**Addendum Number:** 01

**Addendum Issue Date:** February 1, 2021

**Project Name:** CMH Ortho Clinic Addition and Renovation

**Project Number:** 0200707.00

## C2.0

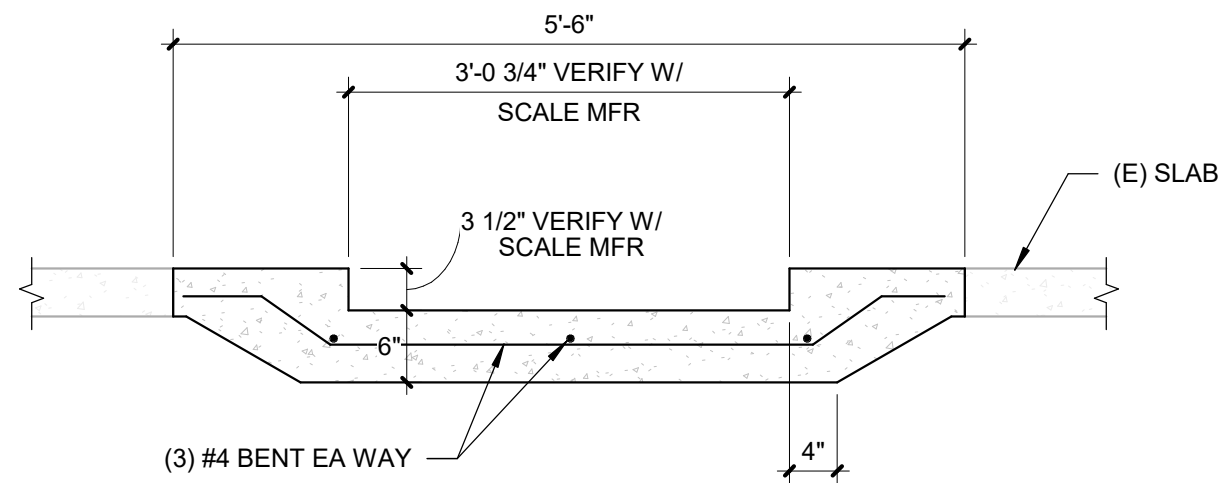
1. Sheet C0.1 – GENERAL NOTES
  - a. REVISE pavement and walk sections. See the attached reissued sheet.
2. Sheet C2.0 – SITE PLAN
  - a. REVISE pavement and walk sections. See the attached reissued sheet.
3. Sheet S1.1 – FOUNDATION PLAN
  - a. UPDATE Footing F1 thickness. See the attached reissued sheet.
4. Sheet S3.1 FOUNDATION DETAILS
  - a. UPDATE pedestal size and reinforcement in Detail 11. See the attached reissued sheet.
5. Sheet AD1.1 – FIRST FLOOR DEMOLITION PLAN
  - a. ADD demolition keynote D10-09 to include removal of existing room signs in the corridor, as shown on the attached reissued sheet.

**A1.1**

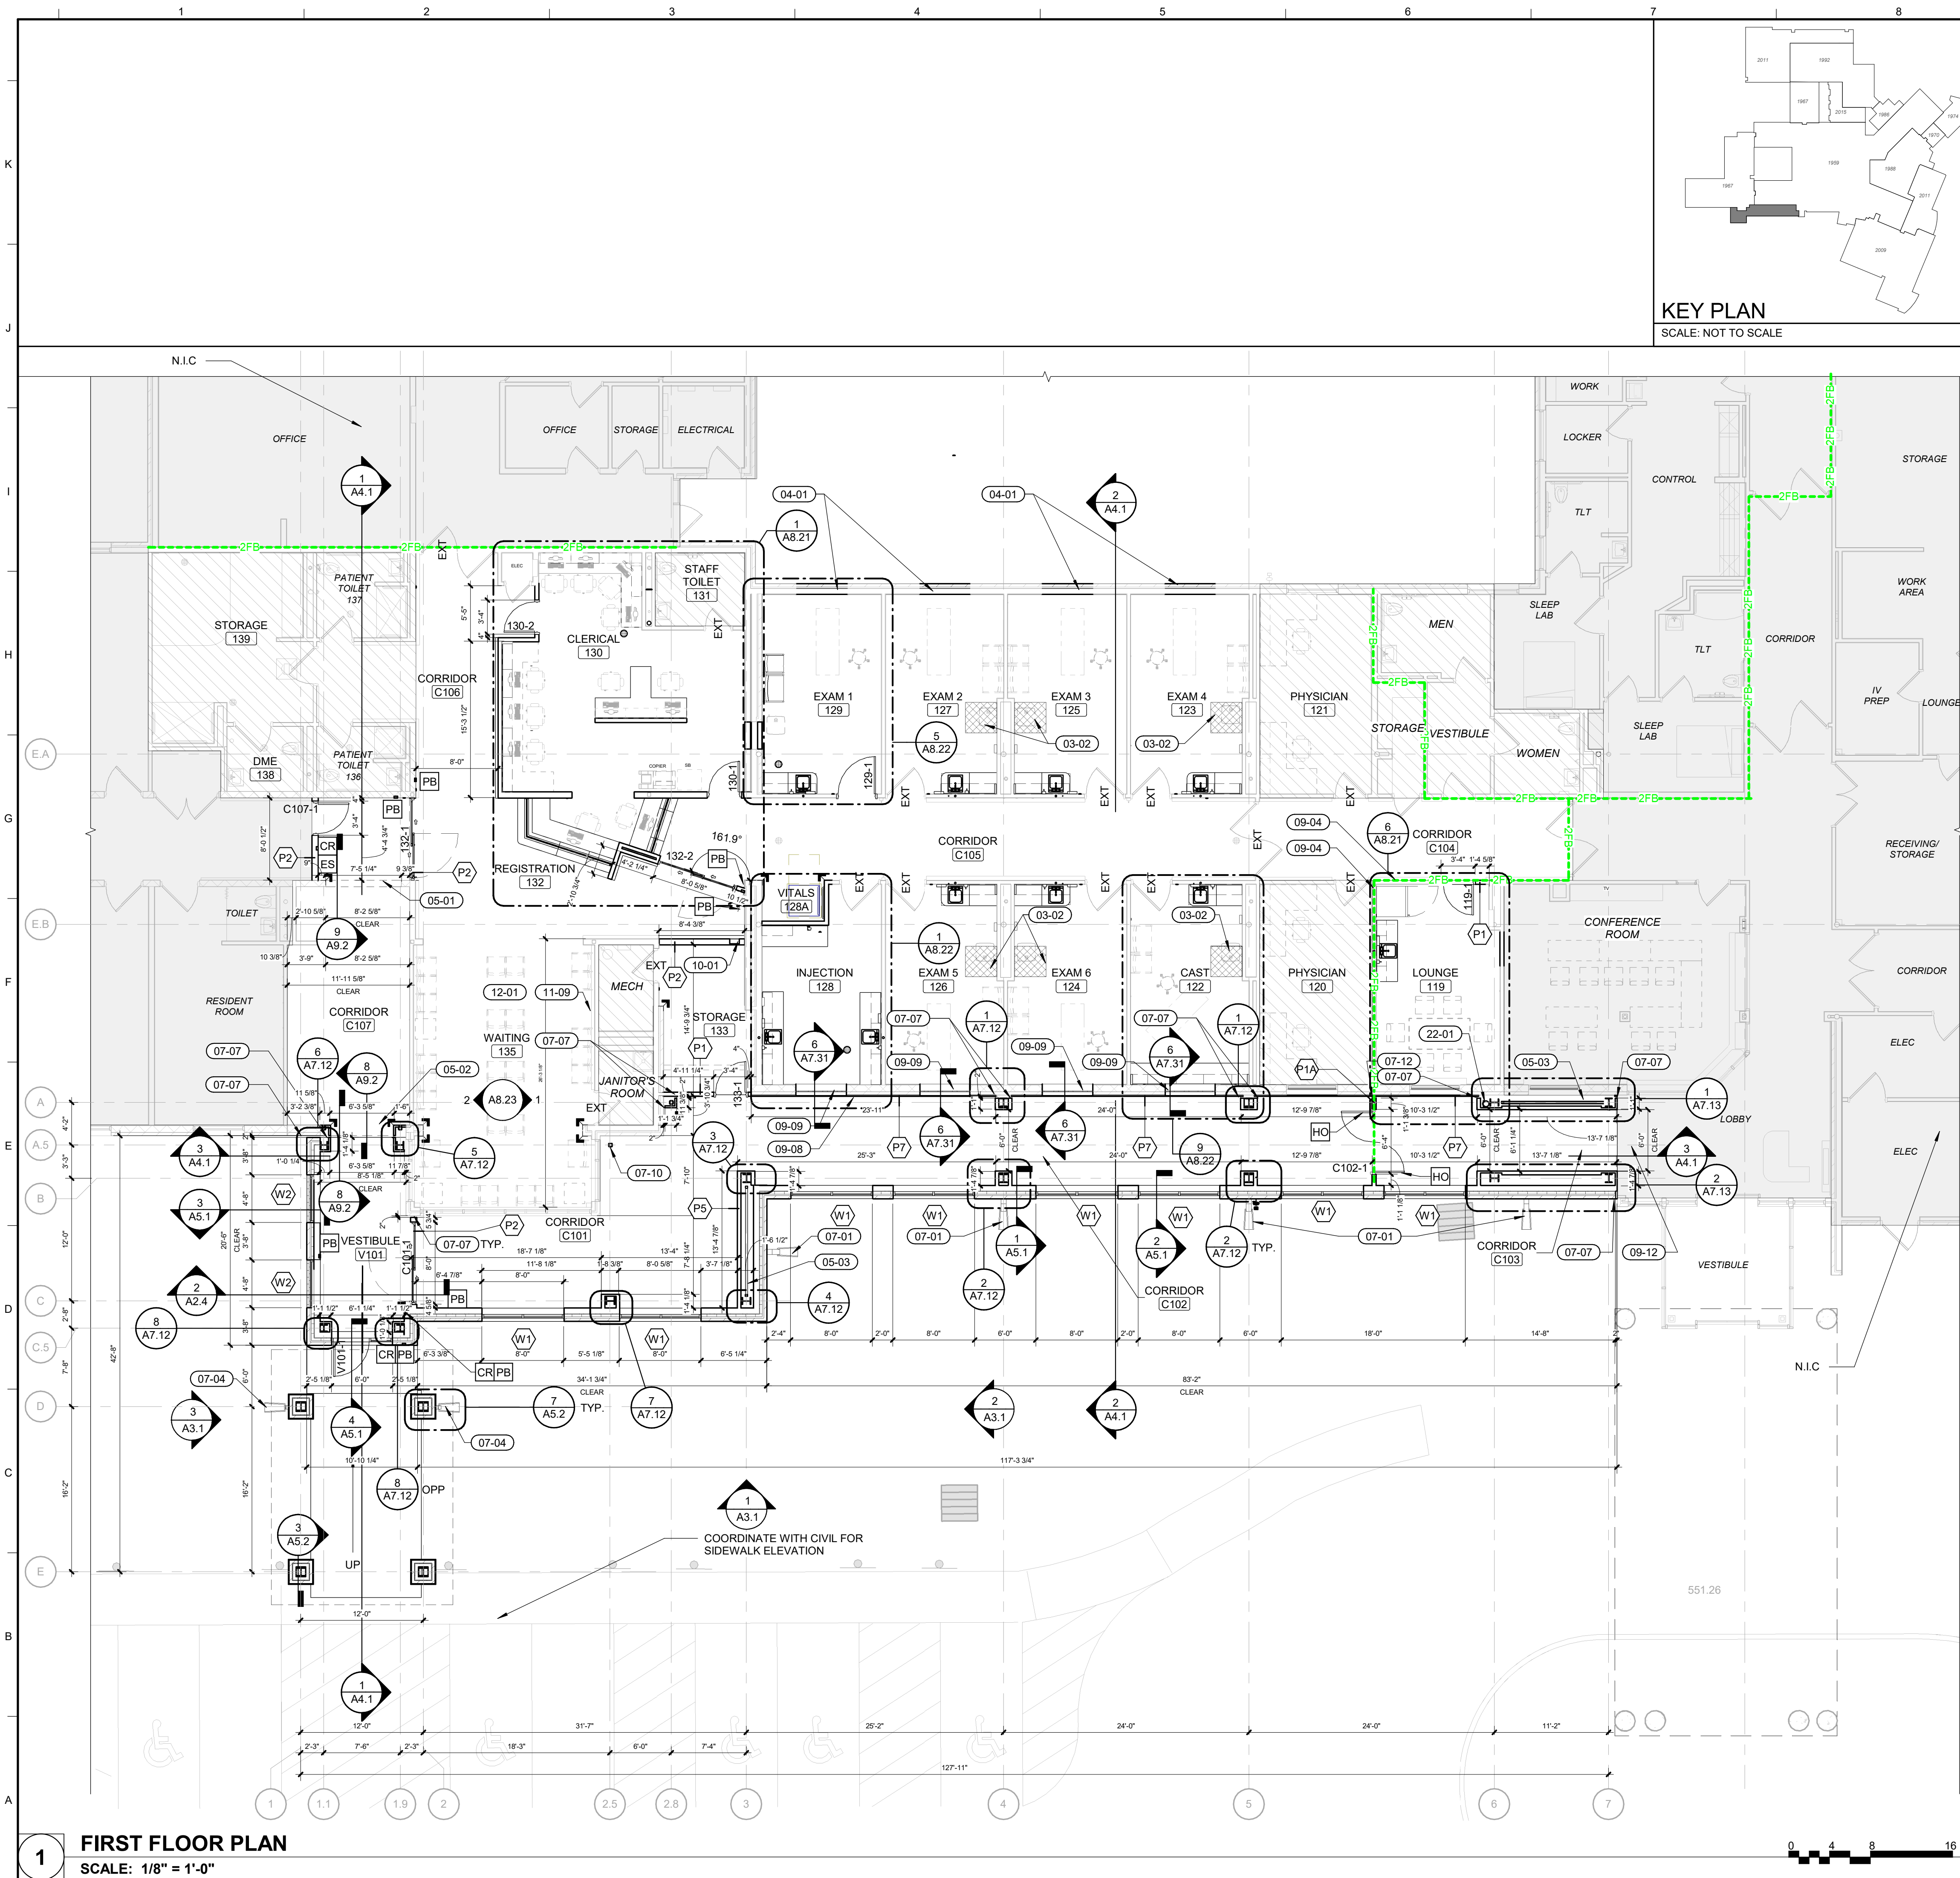
6. Sheet A1.1 – FIRST FLOOR PLAN

- a. REVISE patching note D and update plan general notes. See the attached reissued sheet.
- b. Patching general note D & E is required throughout the project.

SHEET TITLE:  
**ENLARGED  
VESTIBULE PARAPET  
SECTIONS & CANOPY  
DETAILS**

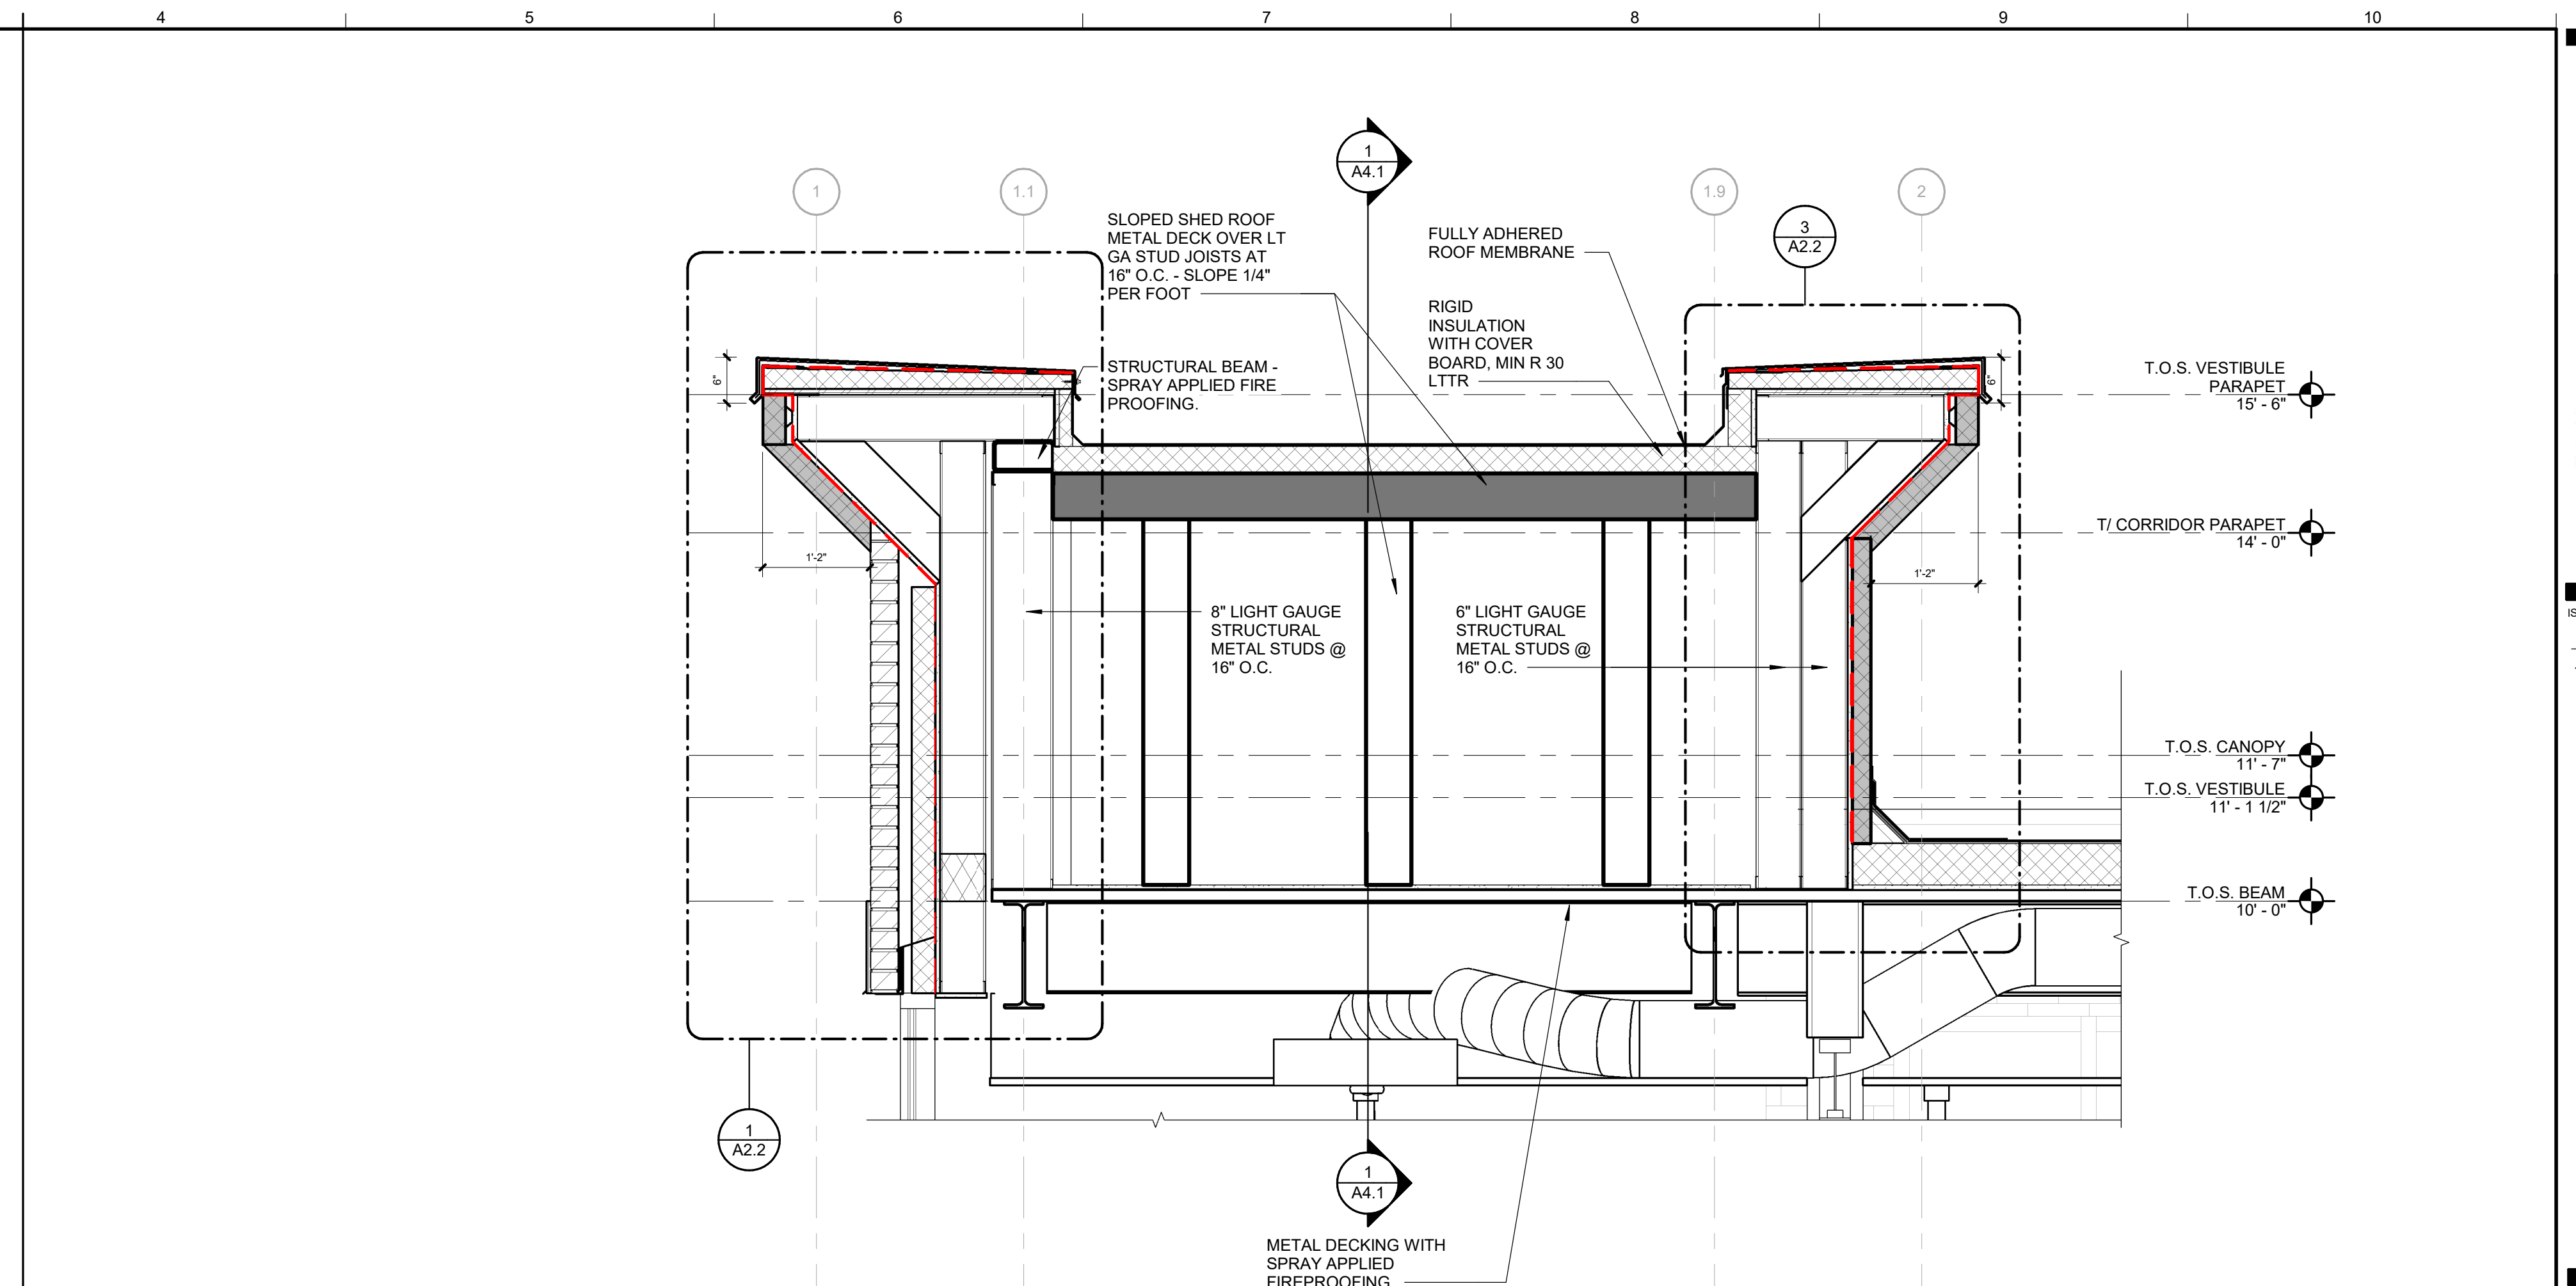
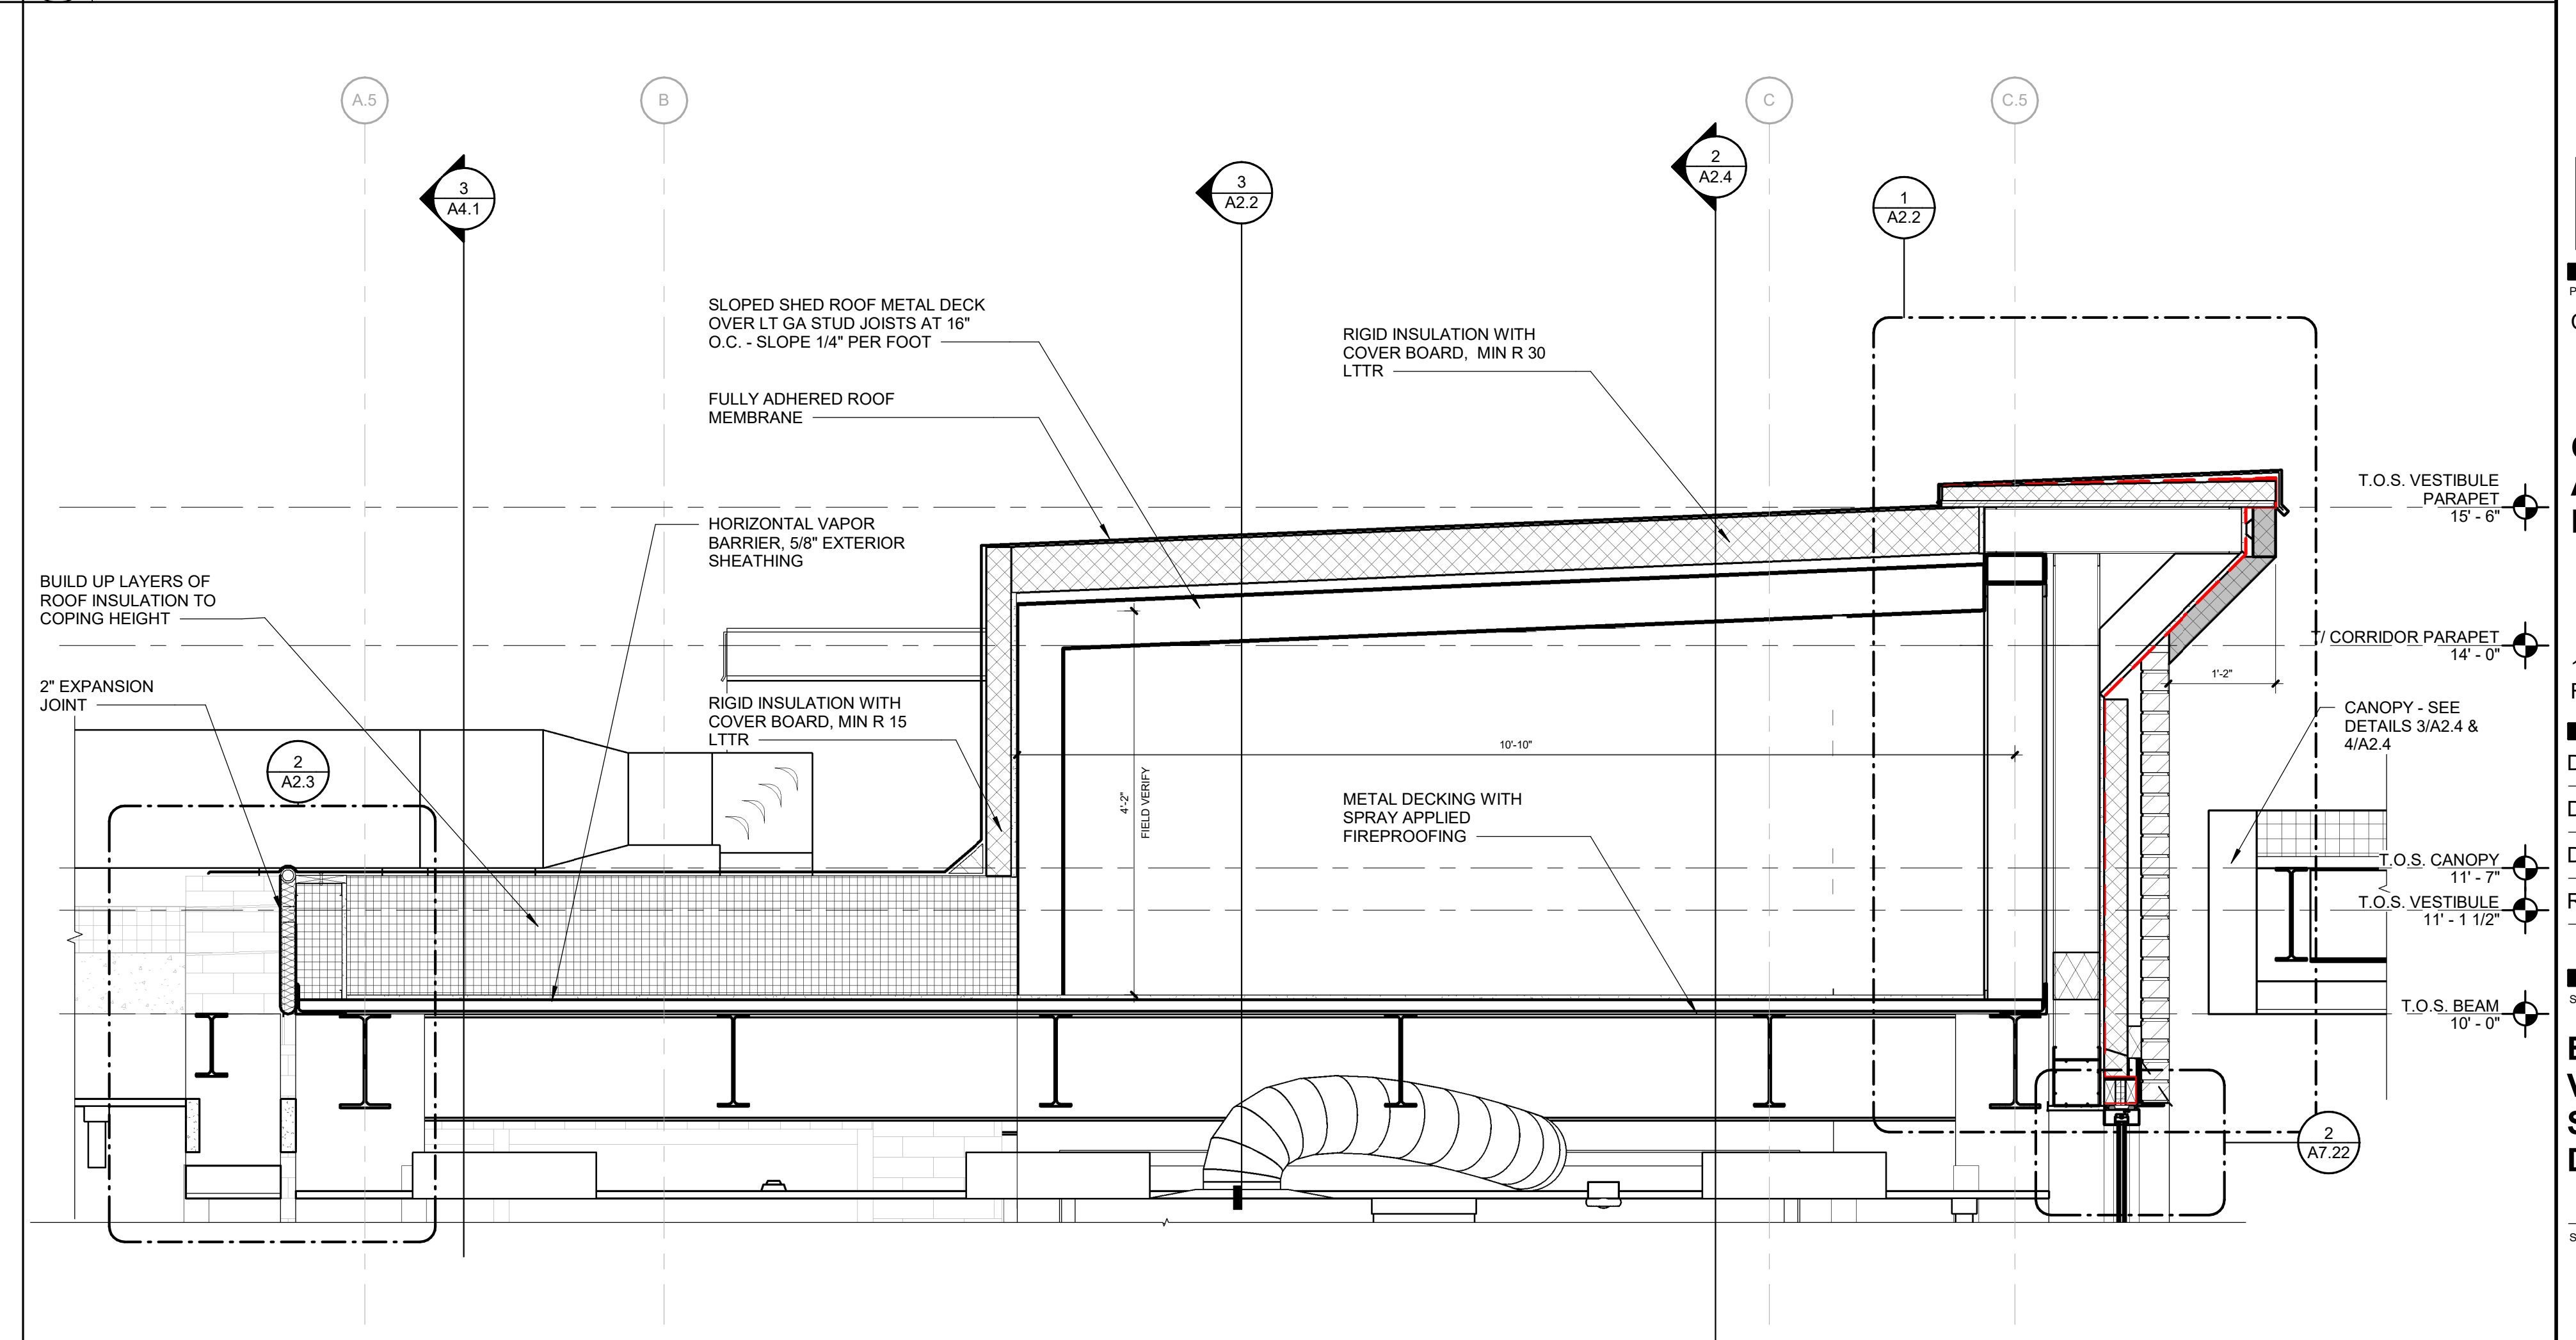
7. Sheet A2.4 – ENLARGED VESTIBULE PARAPET SECTIONS AND CANOPY DETAILS

- a. REVISE composite metal panel joint to the edge of the canopy brick column, as shown on the attached reissued sheet.
